Subject: **COLUMBIA GENERATING STATION, DOCKET NO. 50-397
RESPONSE TO REQUEST FOR ADDITIONAL INFORMATION
RELATED TO EXIGENT LICENSE AMENDMENT REQUEST FOR
CHANGE TO TECHNICAL SPECIFICATION 3.8.7 DISTRIBUTION
SYSTEMS – OPERATING**

RESPONSE TO REQUEST FOR ADDITIONAL INFORMATION

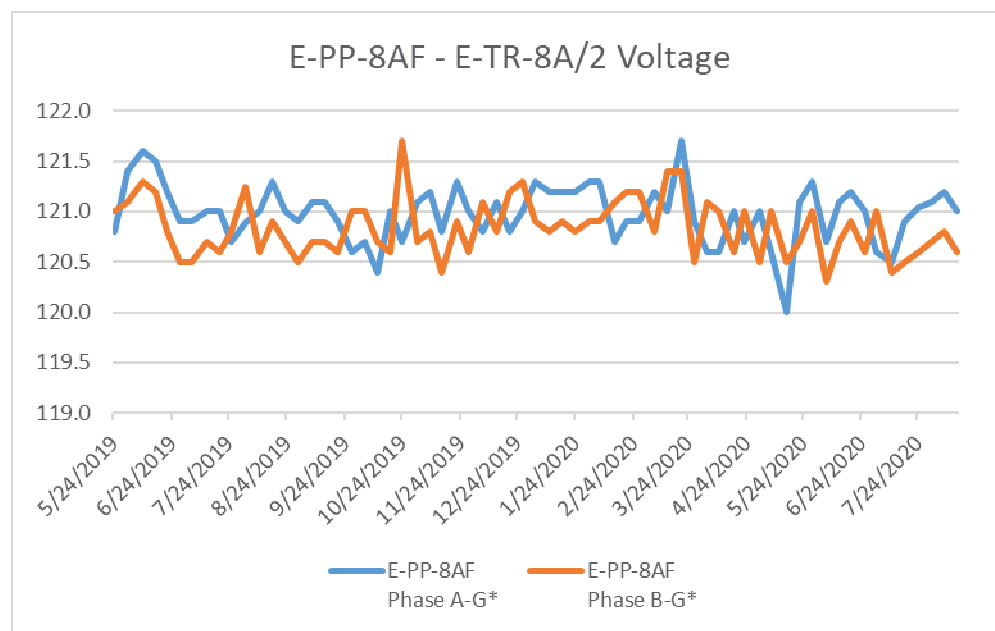
Based on review of responses to RAI No. 2 and 5, in order to provide confidence that the following three voltage regulating type distribution transformers (which are also nearing their end of life - approximate 10 years from the date of last installation) would not fail/degrade during the requested allowed outage time (AOT) extension, please provide voltage plots for the following power panels (similar to voltage plots for panels E-PP-8AE, E-PP-7AE provided in response to RAI No. 5 Question 1).

E-PP-8AF (E-TR-8A/2)

TS Bases 3.8.7 AC Distribution Systems Operating notes that OPERABLE AC electrical power distribution subsystems require the associated buses to be energized to their proper voltages. The figure below plots data obtained from weekly voltage surveillance under TS Surveillance Requirement (SR) 3.8.7.1 for E-PP-8AF.

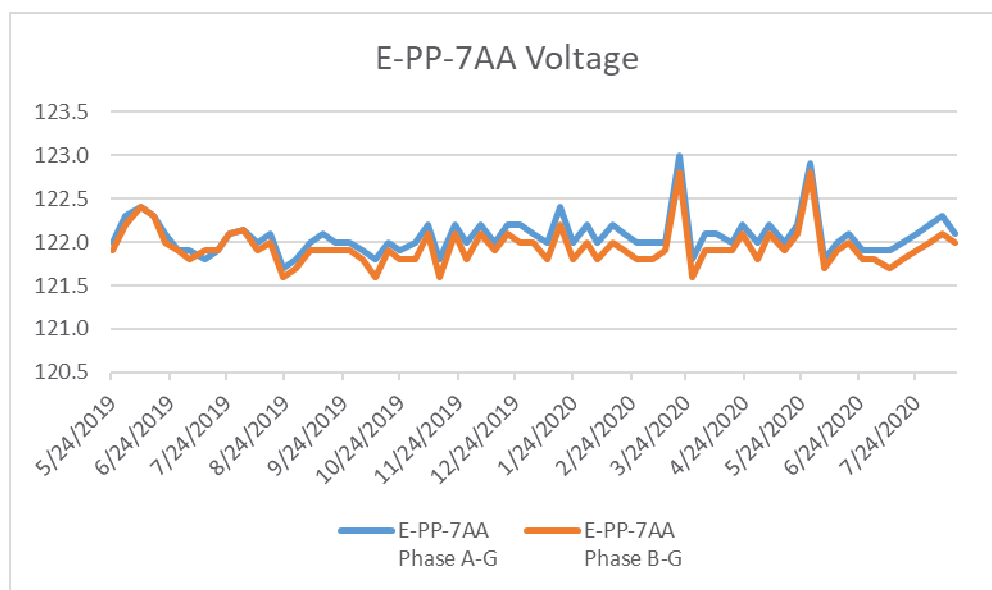
E-PP-7AA (E-TR-IN/3)

Weekly voltage surveillance under TS SR 3.8.7.1 is done by the station for the power panels E-PP-7AA and E-PP-8AA. These readings represent inverter supplied voltage and not E-TR-IN/2 or E-TR-IN/3 supplied voltage. However, the static switch monitors the voltage from these transformers and provides an alarm. This alarm goes to the in-service inverter for “Alternate Source Undervoltage” light on the front of each inverter and provides a main control room trouble alarm input either “IN-2A/2B Trouble,” or “IN-3A/3B Trouble.” The alarm is set at 216 volts alternating current (VAC) which would indicate that E-TR-IN/2 or E-TR-IN/3 have a degraded output. The main control room trouble alarm prompts Operations to respond according to their alarm procedure for each inverter.

A condition report search was performed for the past two years which shows that these alarms have come in three times for “IN-3A/3B Trouble.” Although the alarm came in three times from the “Alternate Source Undervoltage” input alarm for E-IN-3A/3B, they were due to a switching transient and not due to a degraded transformer output.

The voltages that are shown on the following graphs for E-PP-7AA and E-PP-8AA are voltages that are taken with the inverter supplying the vital instrument busses which is the normal and preferred lineup.

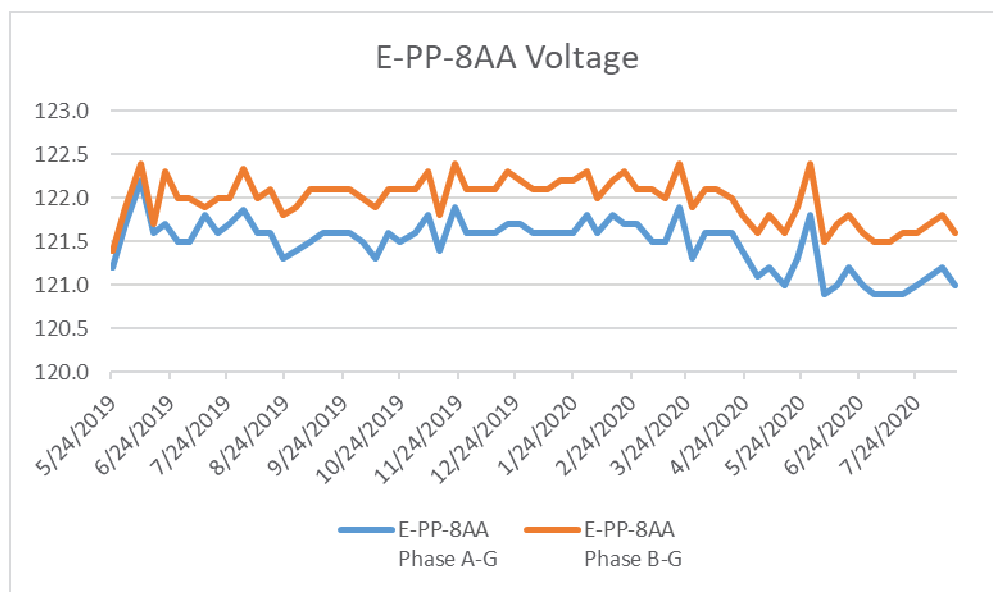
E-PP-8AA (E-TR-IN/2)

Similarly, a condition report search was performed for the past two years which shows that the alarm has come in once for “IN-2A/2B Trouble.” This alarm was due to a grid

hit that momentarily took the inverter and alternate source out of sync. The condition was corrected after the grid hit and it was not from a degradation of E-TR-IN/2.

Based on available data and the fact that these transformers are "current" per station PM strategy, there is no evidence to suggest these transformers would fail during the planned replacement of E-TR-8A/1.
